PERMIT

A REPAIR

SEWAGE DISPOSAL SYSTEM
MARYLAND STATE DEPARTMENT OF HEALTH

ADDRESS 1720 Woodstock Road, Woodstock, Md. 21163 PHONE 465-8921

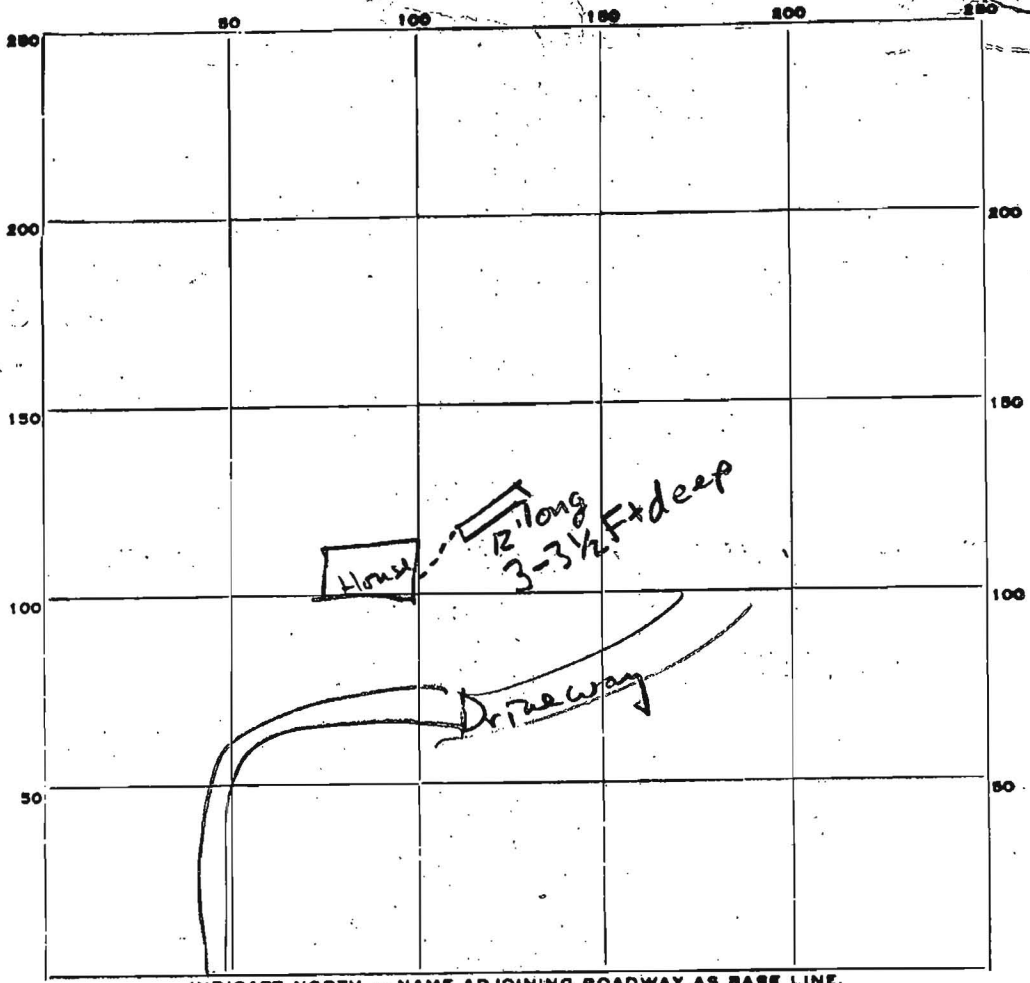
REMARKS Temporary trench only; Make trench longer & or deeper. Put in stones to 10" below top. Put perforated pipe in at 10" with stones to cover. That leaves 6". Call for insp. before putting on paper and the last 6" of dist. MS 4/24/77
